Our Ref: 233574-BWB-ZZ-XX-T-W-0005_LLFA
Date: 8th April 2025
Contact: Craig Crowe
Direct Dial: 0115 851 7410

RESPONSE TO LEAD LOCAL FLOOD AUTHORITY CONSULTEE COMMENTS ON OUTLINE PLANNING APPLICATION REFERENCE: 24/2073/OUT – LAND TO NORTH OF LITTLE GREEN LANE, CROXLEY GREEN, WD3 3SP

Appendix 1: Updated Illustrative Drainage Strategy

ILLUSTRATIVE DRAINAGE STRATEGY

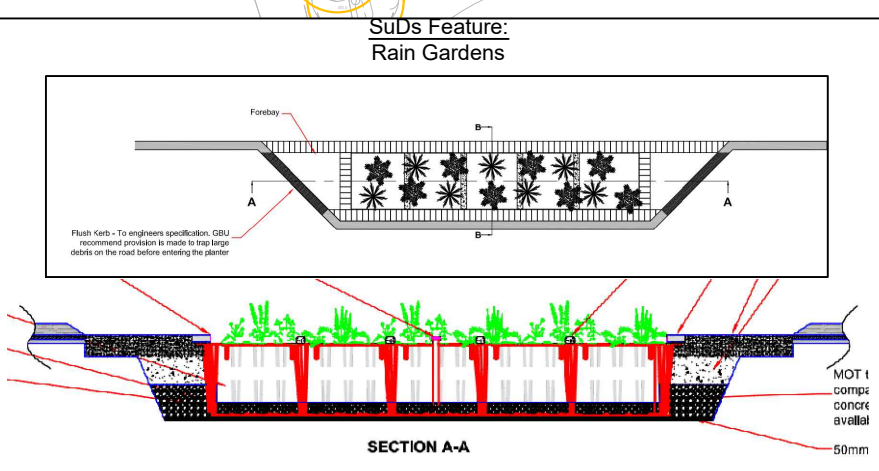
“Masterplan drawings need to show the high-level location of all SuDS and demonstrate that the volume of storage can be achieved within the layout. This includes the consideration for constraints (e.g., pipeline crossings and how gravity drainage can be achieved). Whilst we acknowledge that the location of SuDS has been outlined (Appendix 11), it is unclear how the principles of drainage would operate. The connections between the features are unclear (i.e. swale does not connect to anything) and the outfall is unclear.”

“Indicative vehicular access route and offroad parking needs to be provided to ponds, basins and swales within the masterplan. It is currently unclear where the off-road parking will be for the swales and basins”

The Illustrative Drainage Strategy (reference 233574-BWB-ZZ-XX-D-W-0001) has been updated to show all connections between all SuDS features and highlight flow pathways to clarify the drainage principles. The updated Illustrative Drainage Strategy is included as **Appendix 1** of this letter. An infiltration based solution is proposed and therefore no formal outfall is required.

*The Illustrative Drainage Strategy (reference 233574-BWB-ZZ-XX-D-W-0001) has been updated to illustrate vehicular access routes to the proposed infiltration basins and is included as **Appendix 1** of this letter. Swale features are to be accessed via the public highways or surrounding public open spaces and therefore off-road parking is not considered to be required.*
